**ADDENDUM NO. 1**

**PROJECT NAME:** City Campus Utility Plant North Cooling Tower Replacement General Installation Contract Package

**UNL PROJECT NUMBER:** C028P241  
**BID INVITATION NUMBER:** 2247-13-7200

**CONSULTANT:** Lutz, Daily & Brain, LLC  
6400 Glenwood, Suite 200  
Overland Park, KS 66202

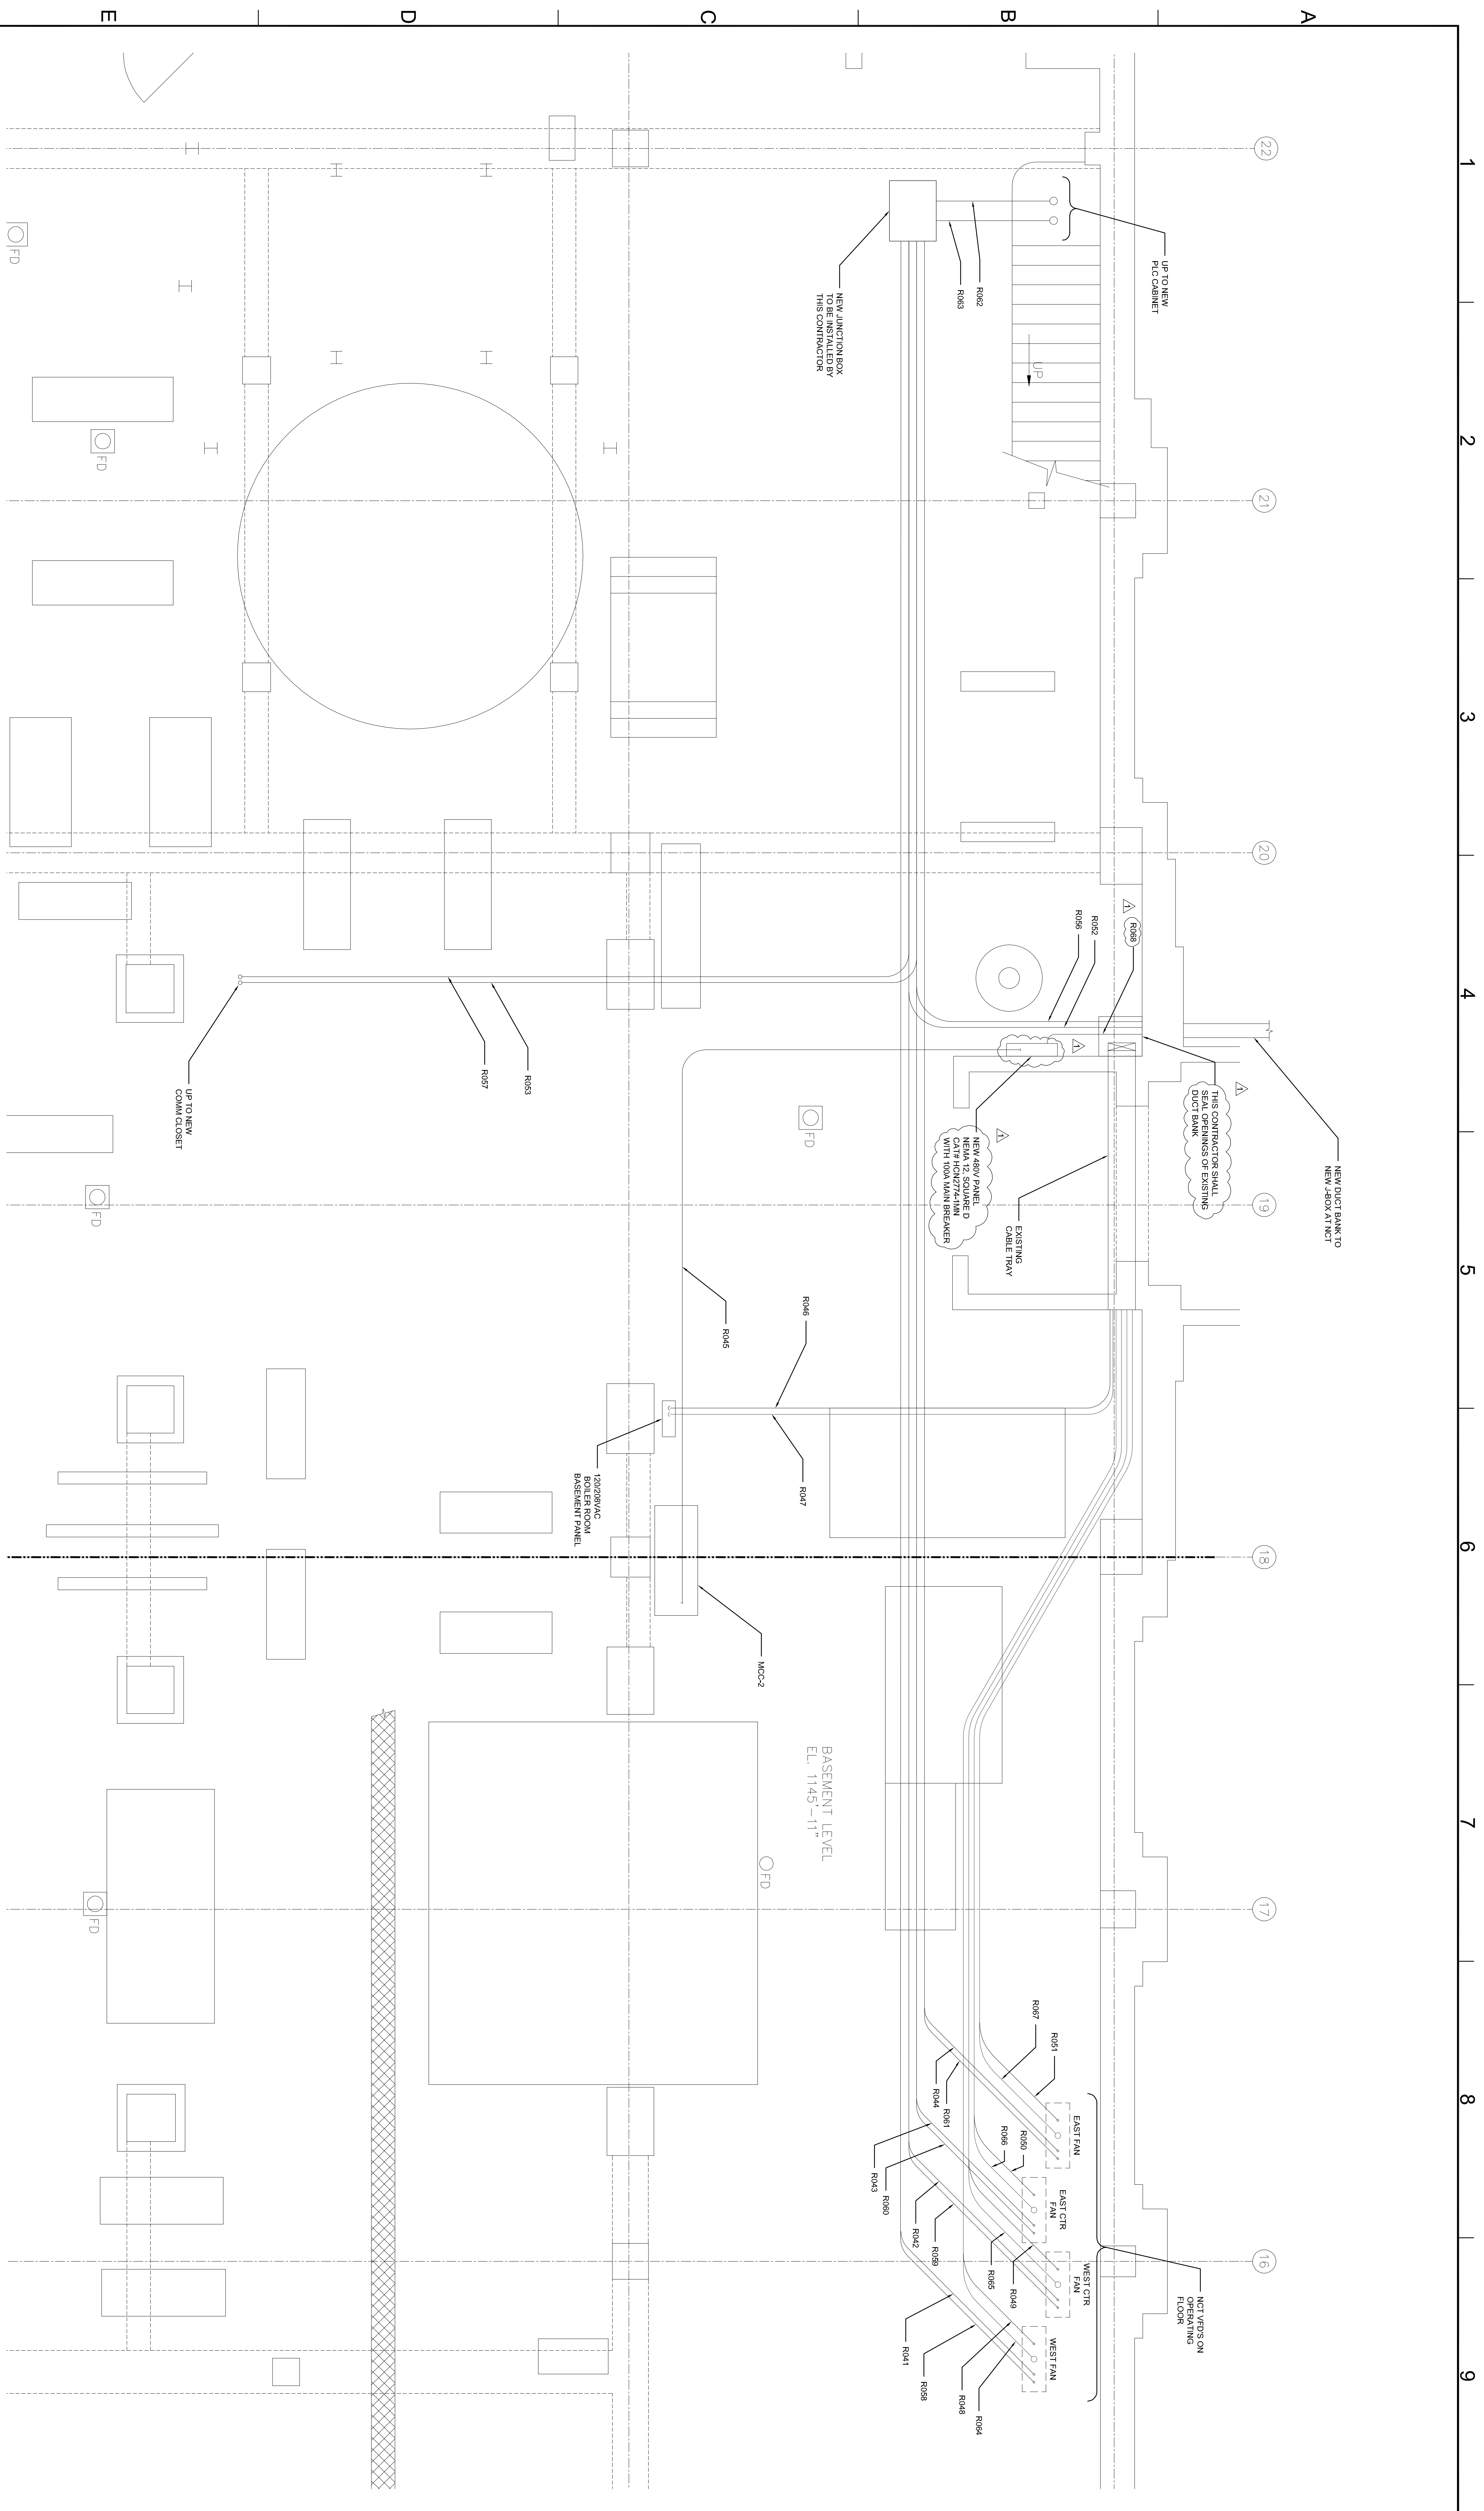
- 13.3 Drawing 40213-CCUP-NCT-E8: Detail of 480V supply enclosure is removed.
- 13.4 Drawing 40213-CCUP-NCT-E10: Add 480V panel onto basement plan view.
- 13.5 Section 26 70 00 Part 2.01 Paragraph B shall read: "Indoor 480V panel with 100A main - Square D Catalog No. HCN2774-1MN with box and surface mount 4-piece trim with door and six three-pole 15A breakers."
